Round One, Set Five
Materials Engineering Branch
121.10

Docket # 58-397
Control # 7907260511
Date 2/24/79 of Document
REGULATORY DOCKET FILE

120.0 MATERIALS ENGINEERING BRANCH

FIGURE 1
FIRST CYCLE VOID COEFFICIENT
FOR STABILITY ANALYSIS

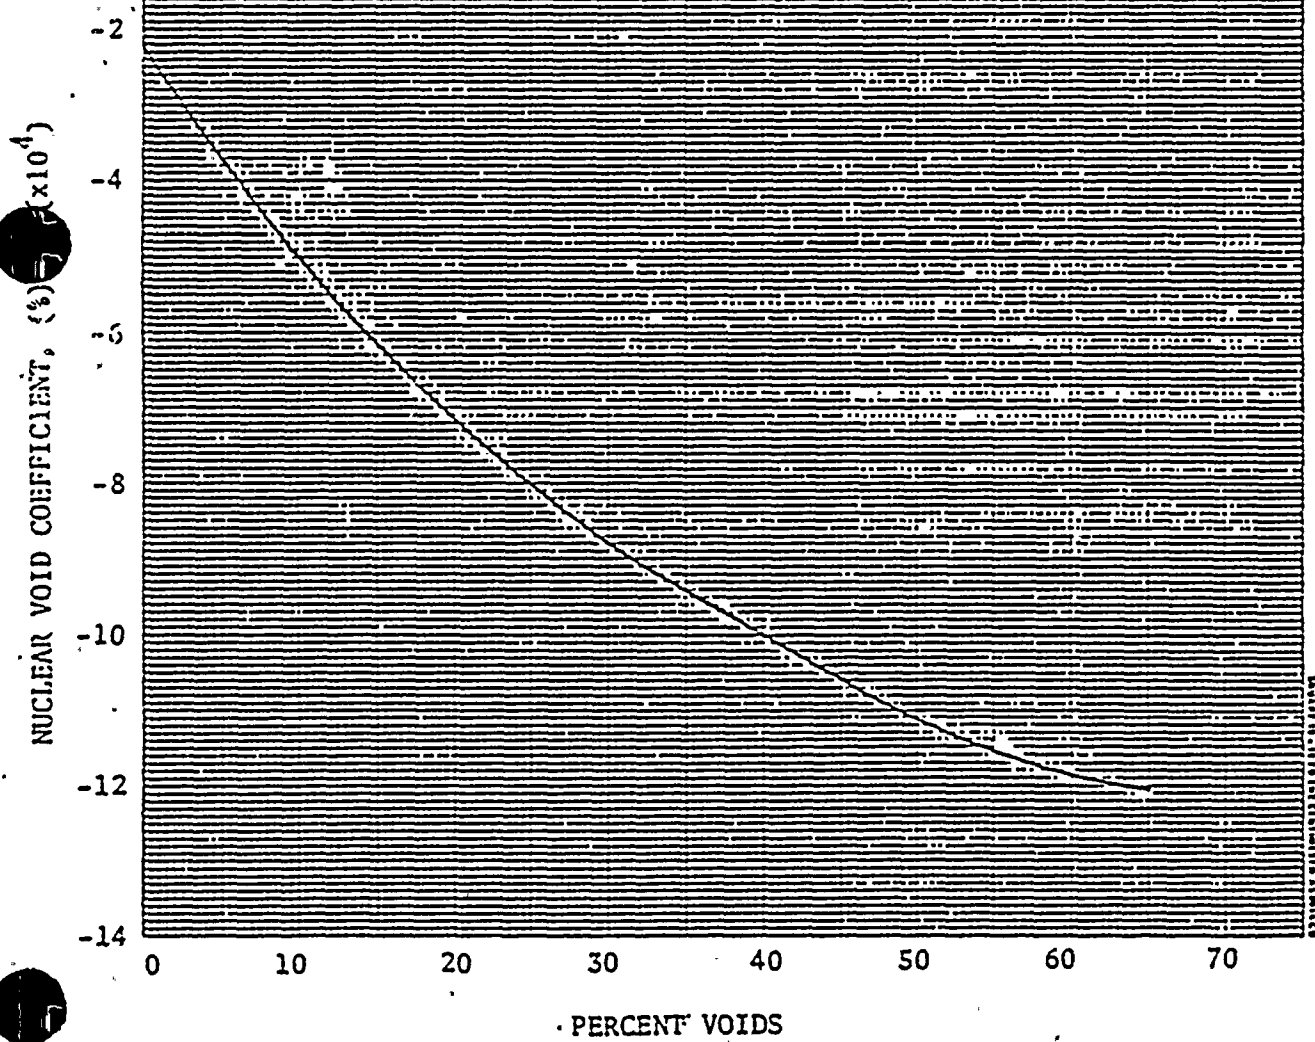
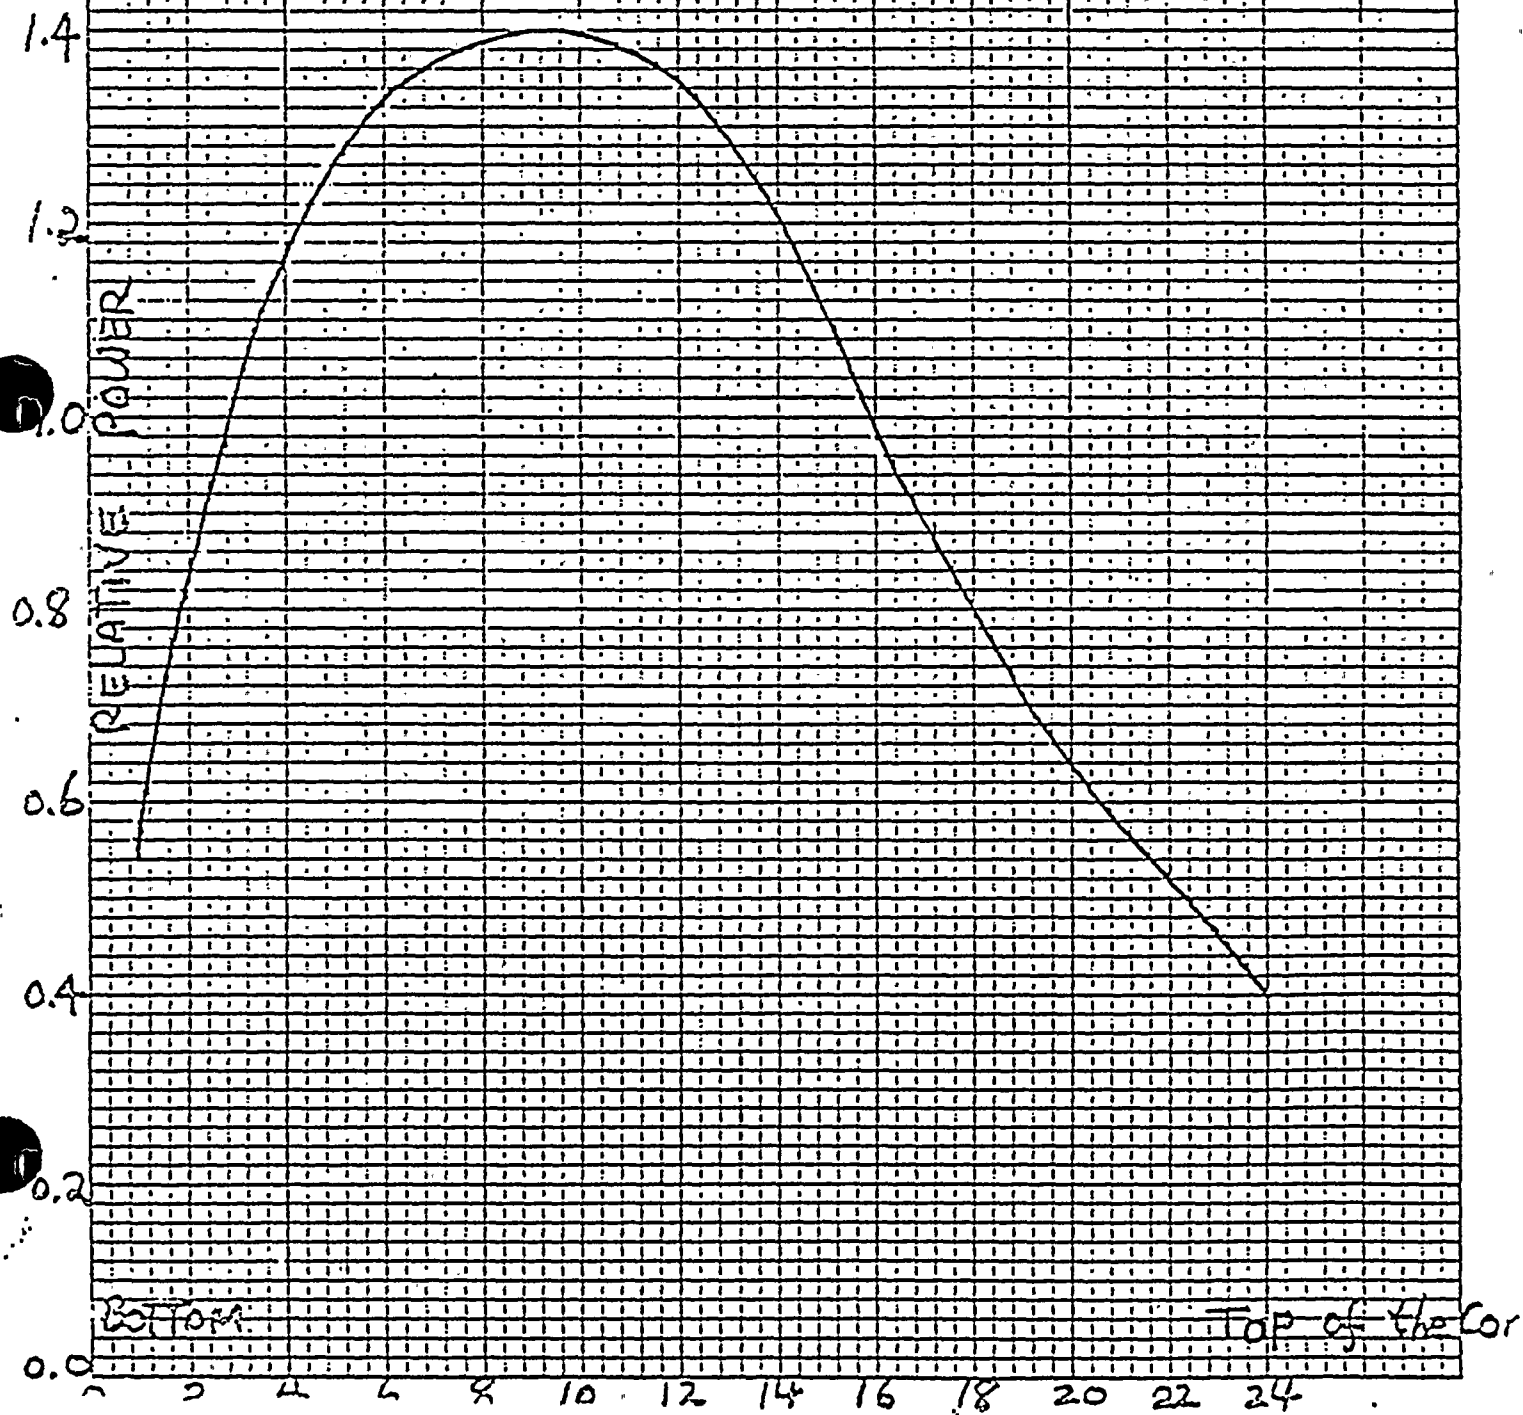
In Section 4.4.4.6.7 of the FSAR, you state that the most limiting condition for thermal-hydraulic stability occurs at the end of core life with power peaking toward the bottom of the core. Indicate whether the typical values of core stability provided in this section are based on the core characteristics at the end of core life. If not, provide values of the decay ratio for this condition. Provide the power profile and the void reactivity coefficients used for this analysis.

The core stability results provided are based on core characteristics near end of cycle 1* condition, which is the most limiting for cycle 1* plant operation.

*Note: Core stability data for those cycles beyond cycle 1 will be provided with the reload license application.

Figure 14.2-6

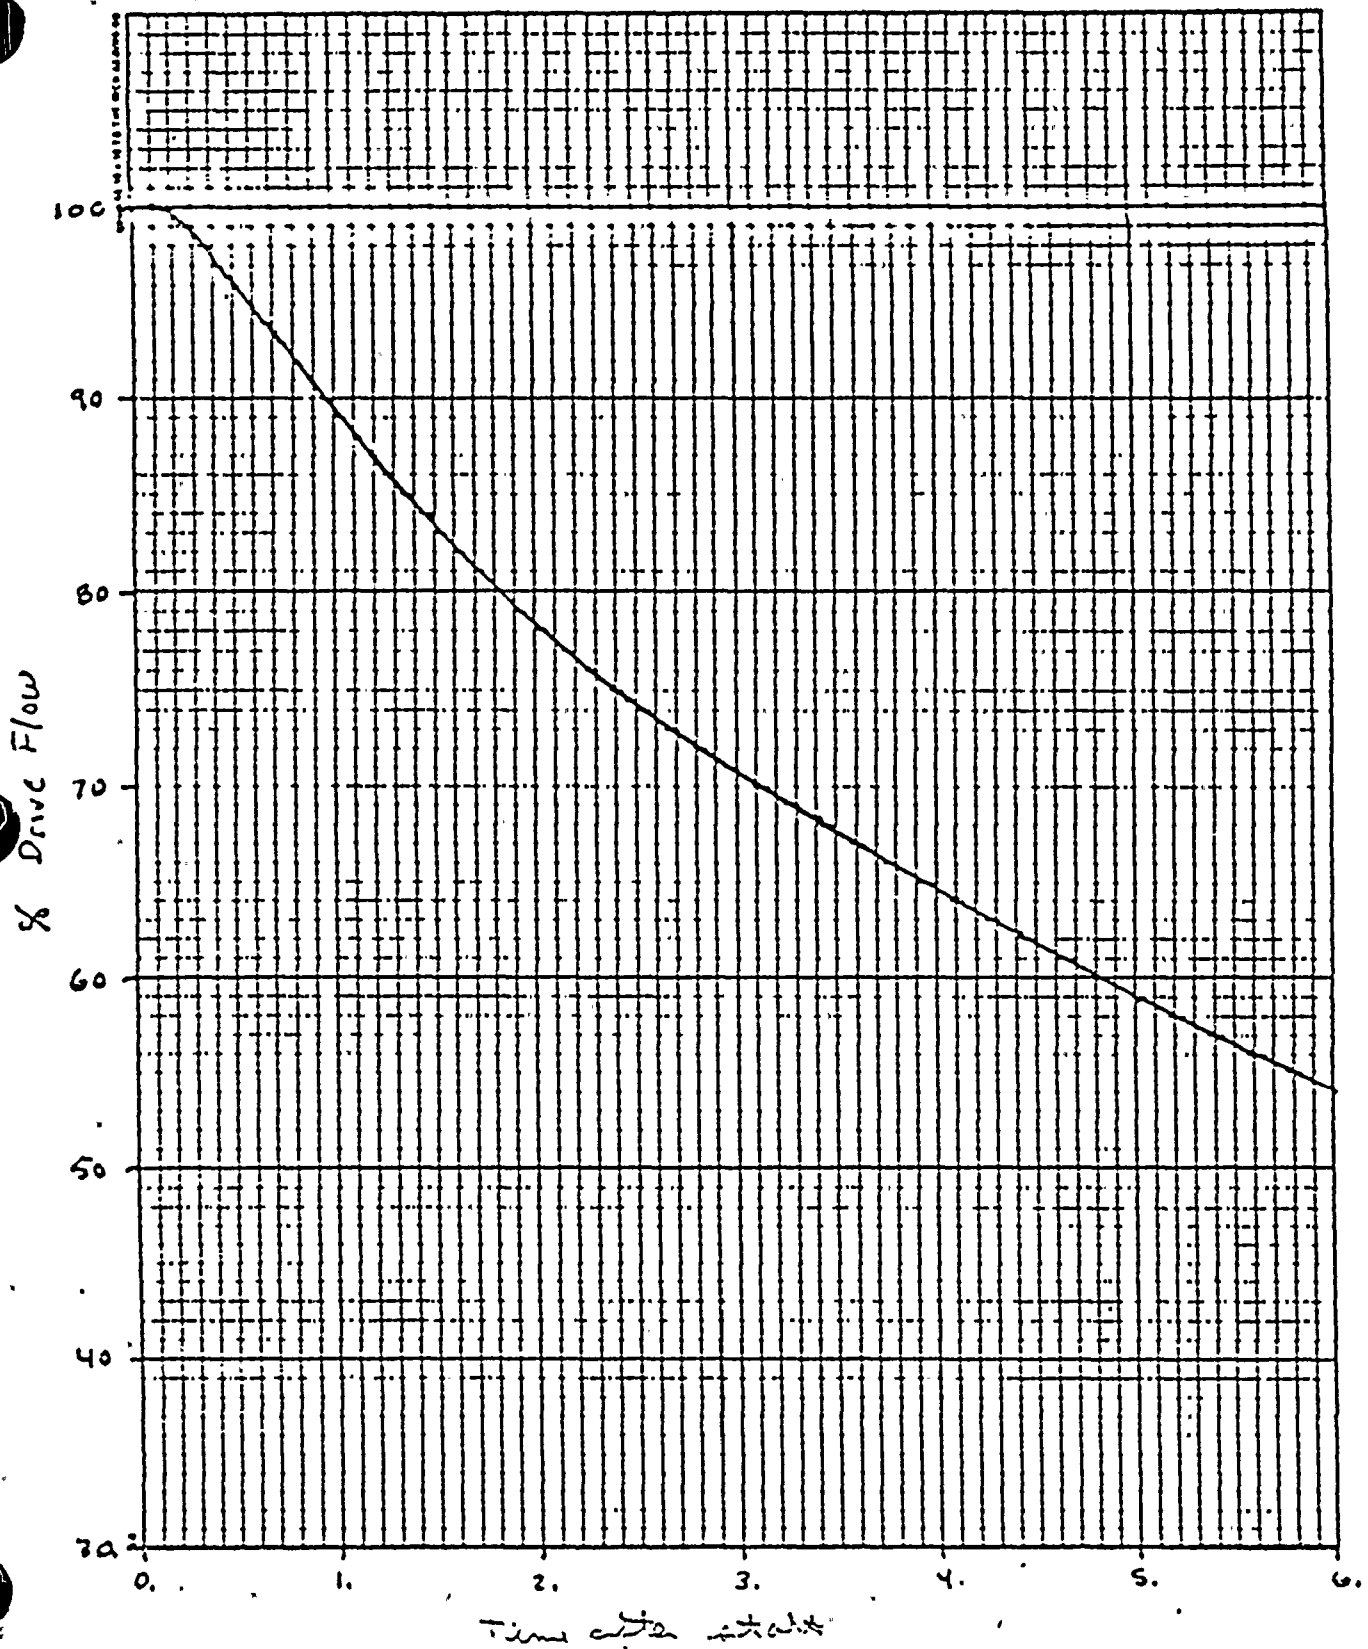
The two pump drive flow coastdown transient during the first 3 seconds must be equal to or greater than that specified on Figure 30-~~2-1~~.
14.2-6.

Figure 2.4-13

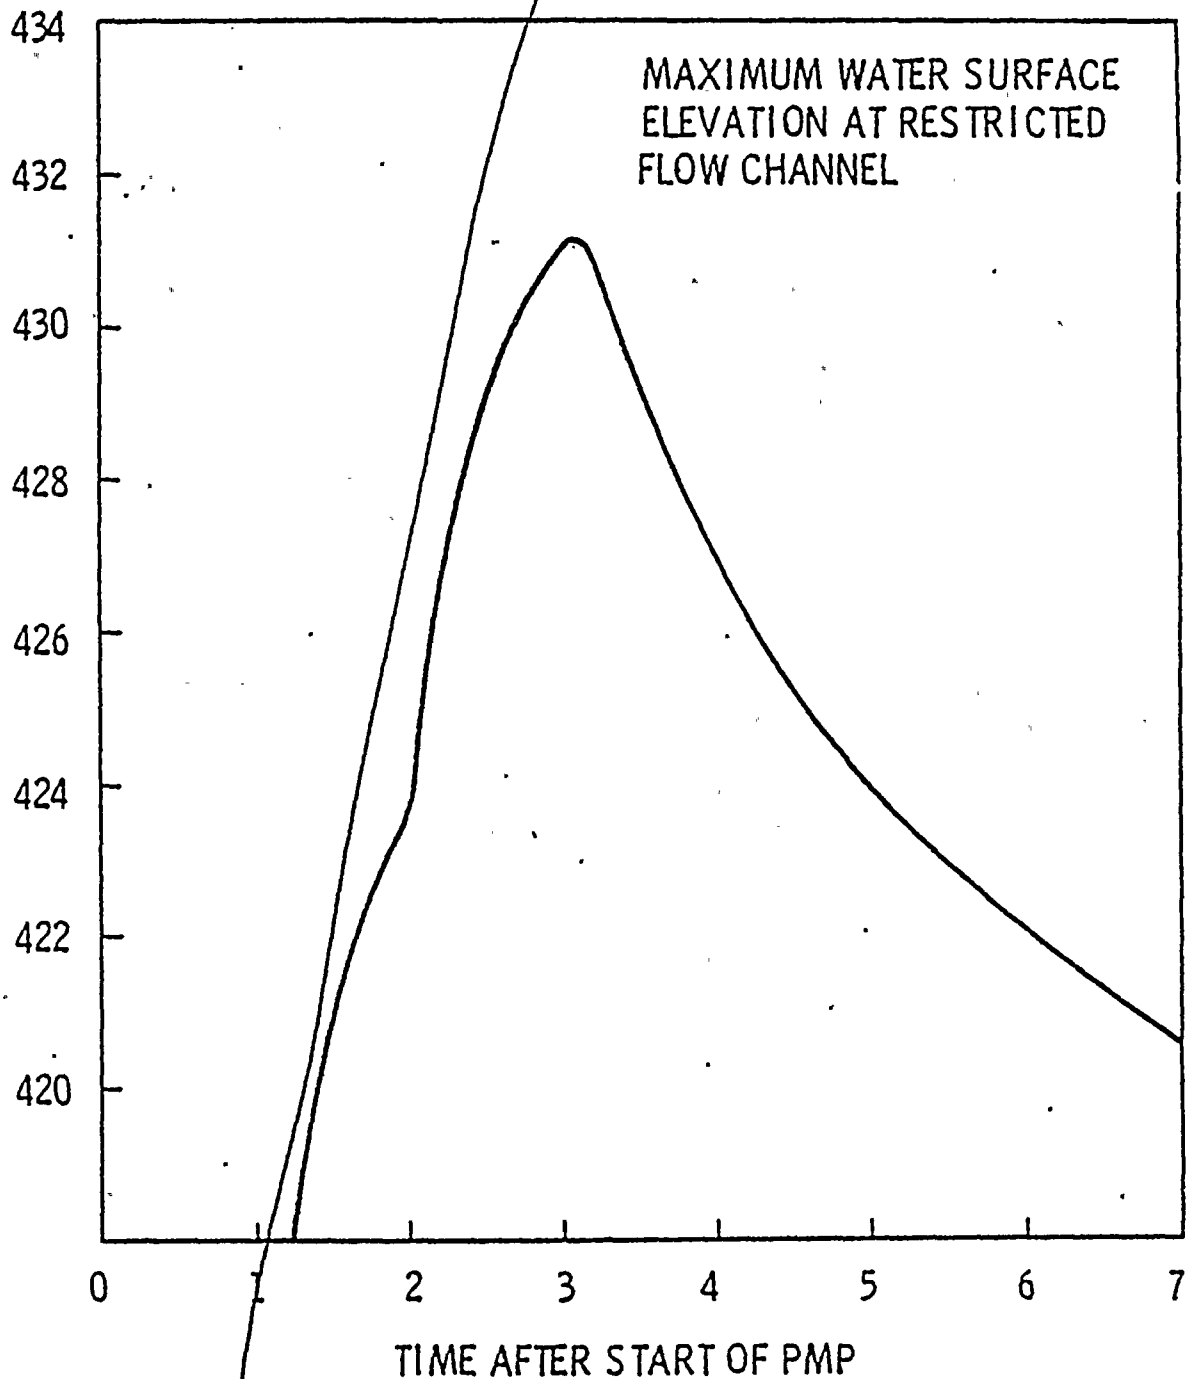
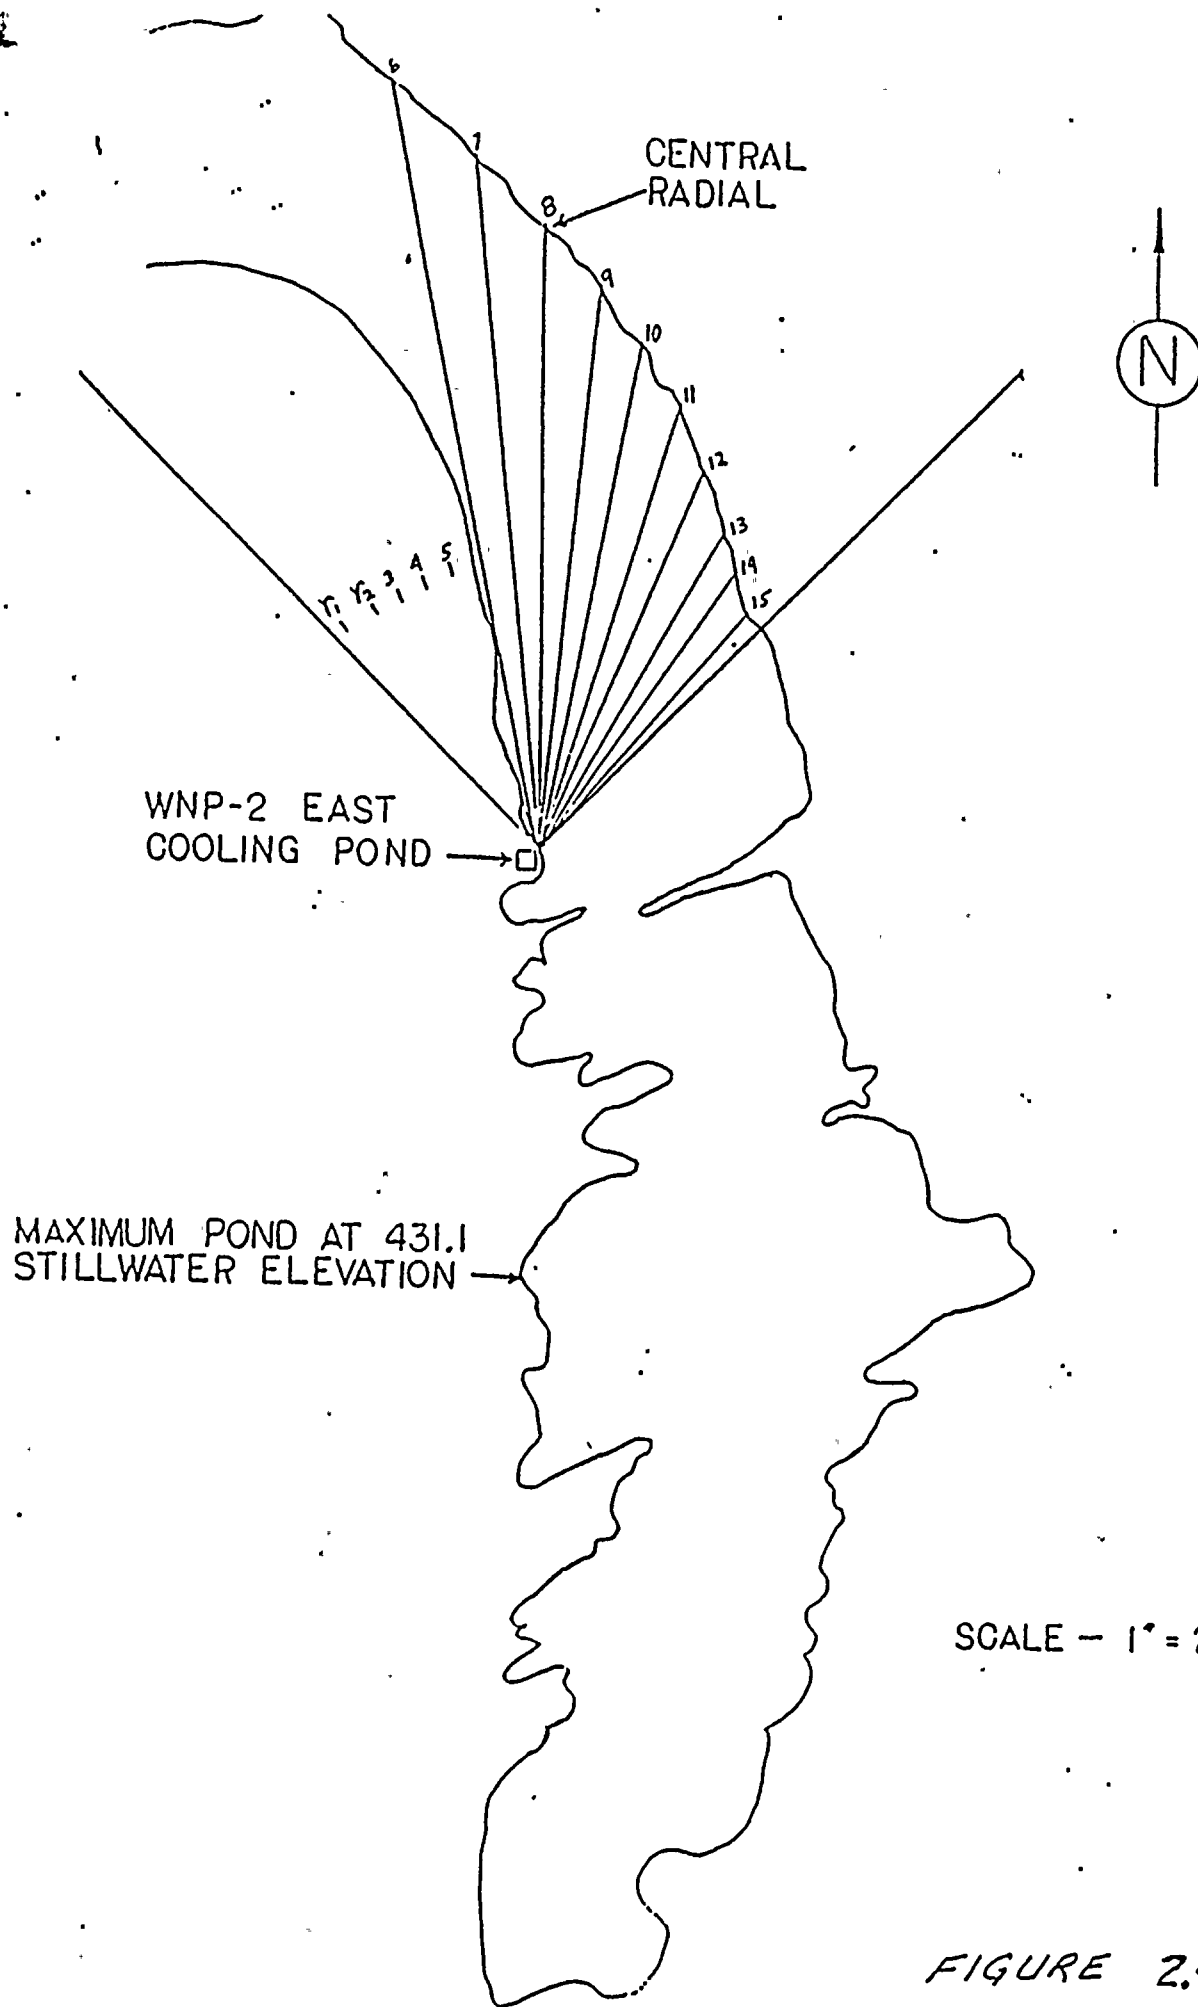
replace figure with attached
